ATTACHMENT 1

UNIT 1
TECHNICAL SPECIFICATION
REVISED PAGES

ATTACHMENT 2

**UNIT 2
TECHNICAL SPECIFICATION
REVISED PAGES**

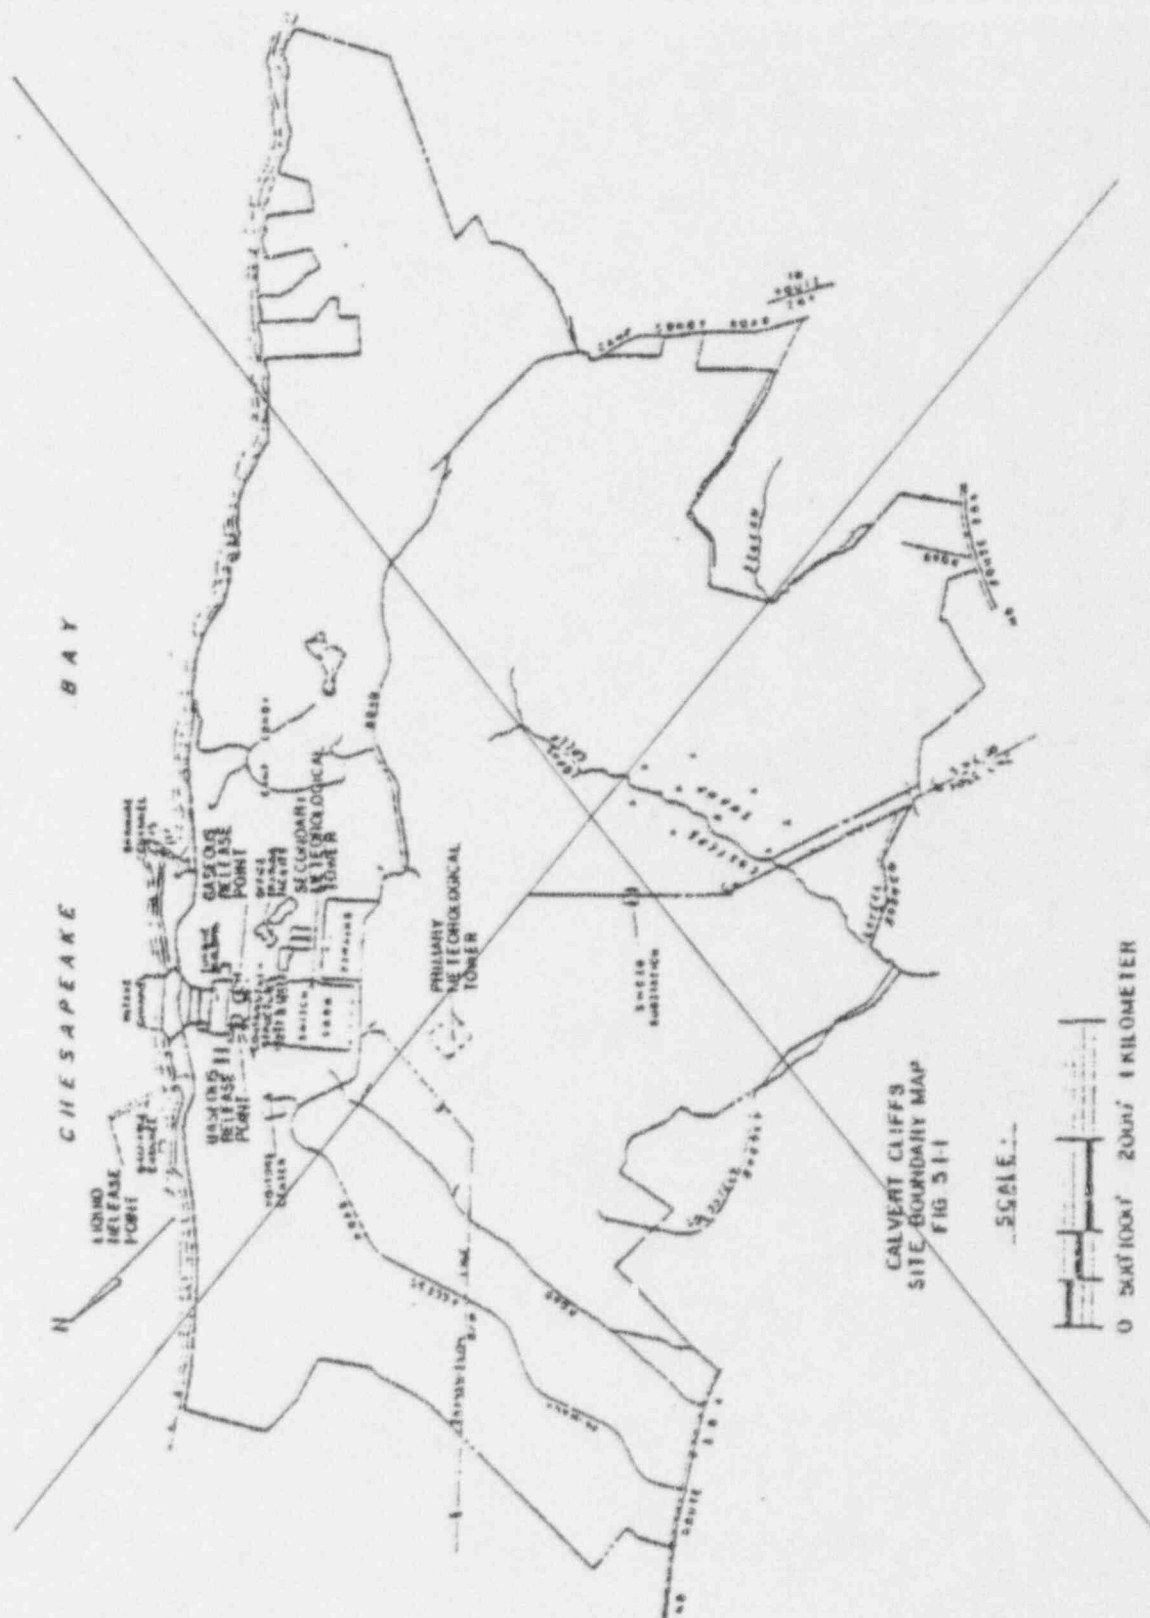
5.1.1 A map of the Calvert Cliffs Nuclear Power Plant site identifying the major plant structures as well as defining the radioactive effluent release points and the **SITE BOUNDARY** is shown in Figure 5.1-1.

[INSERT A]

5.1 SITE LOCATION

The site for the Calvert Cliffs Nuclear Power Plant is located on the western shore of the Chesapeake Bay in Calvert County, Maryland about 10-1/2 miles southeast of Prince Frederick, Maryland. The site is approximately 45 miles southwest of Washington, D.C. and 60 miles south of Baltimore, Maryland.

FIGURE 5.1-2

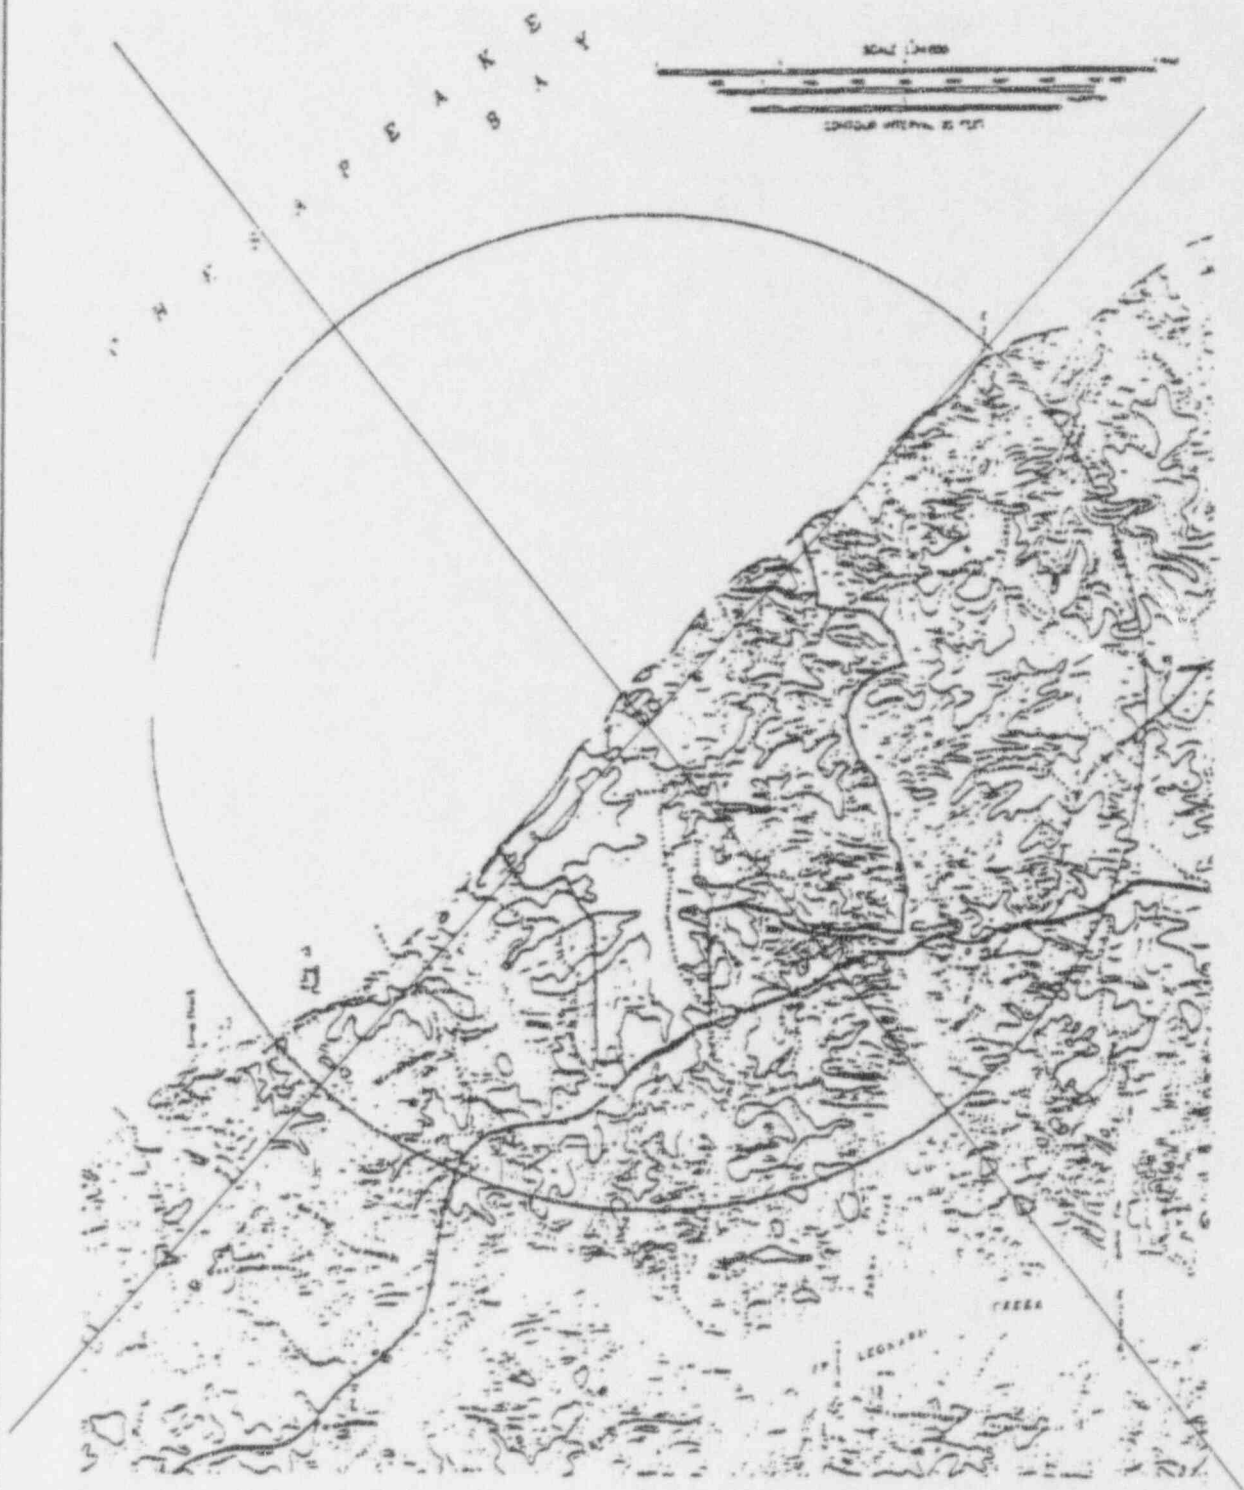
5.1.2 The low population zone shall be as shown in Figure 5.1-2.

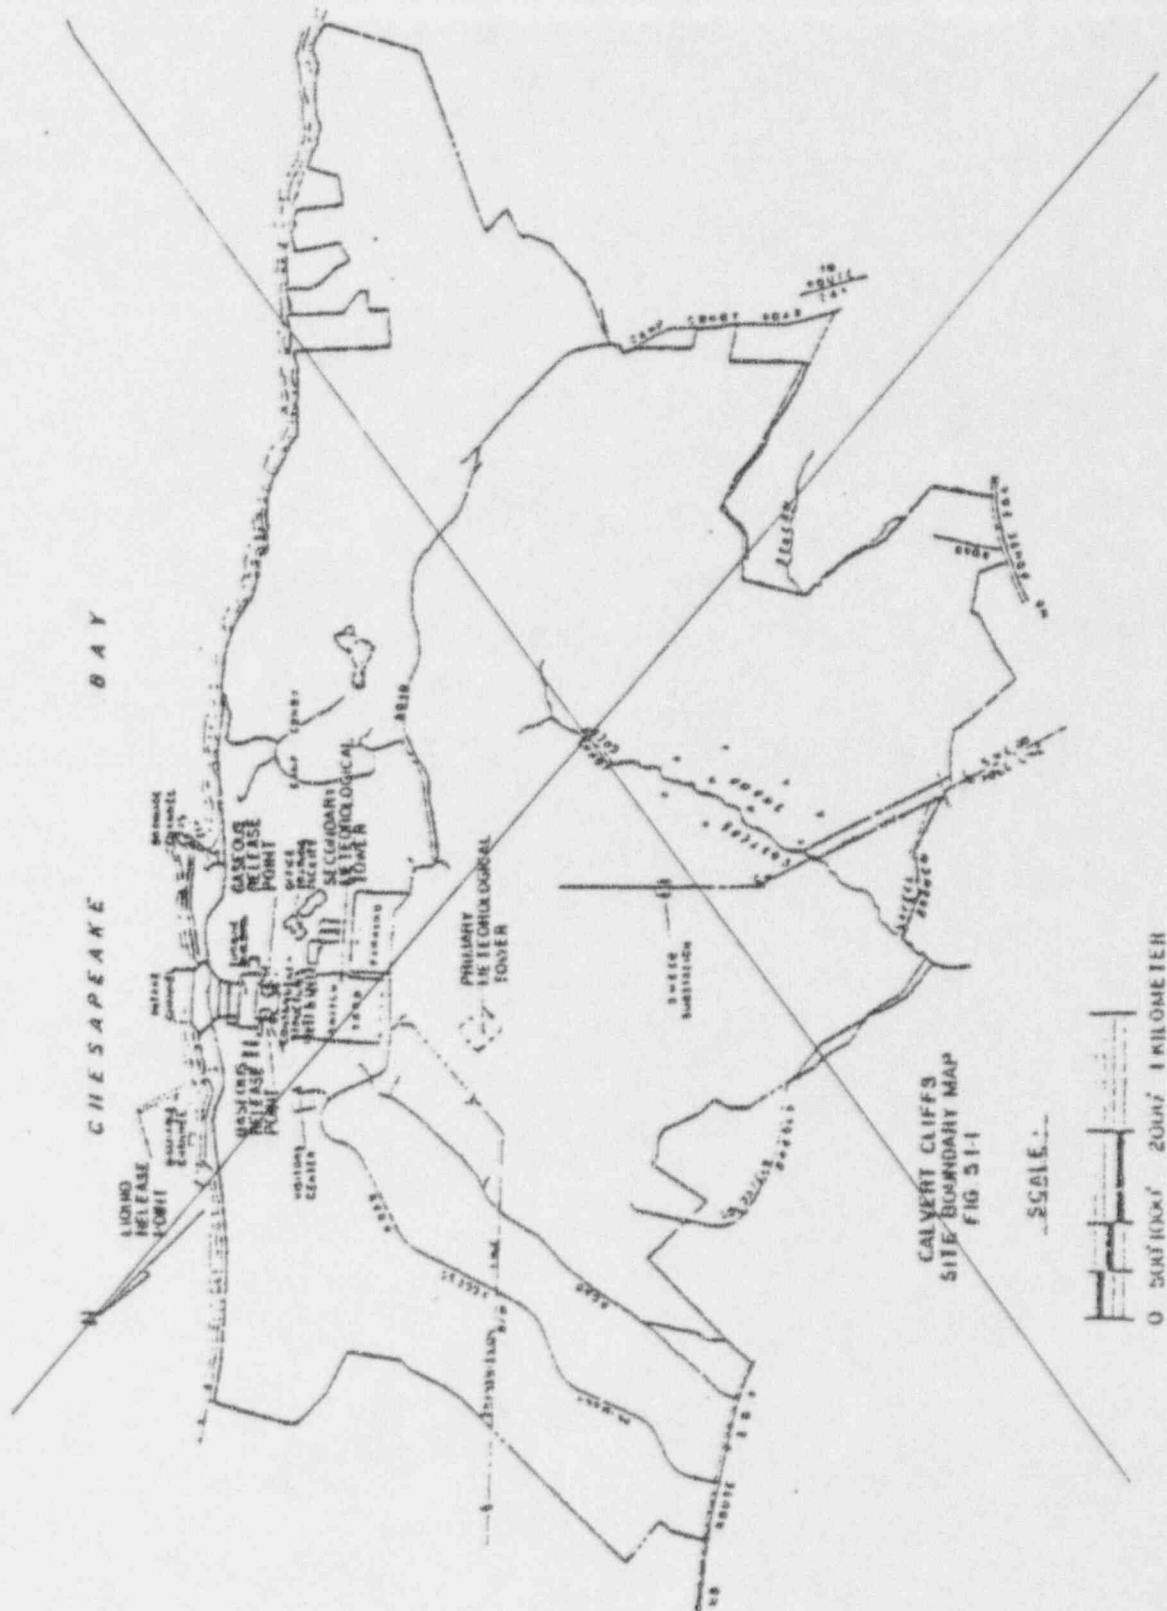
[Delete in Total and Replace with Insert A]

5.1.1 A map of the Calvert Cliffs Nuclear Power Plant site identifying the major plant structures as well as defining the radioactive effluent release points and the **SITE BOUNDARY** is shown in Figure 5.1-1.

[INSERT A]

5.1 SITE LOCATION

The site for the Calvert Cliffs Nuclear Power Plant is located on the western shore of the Chesapeake Bay in Calvert County, Maryland about 10-1/2 miles southeast of Prince Frederick, Maryland. The site is approximately 45 miles southwest of Washington, D.C. and 60 miles south of Baltimore, Maryland.
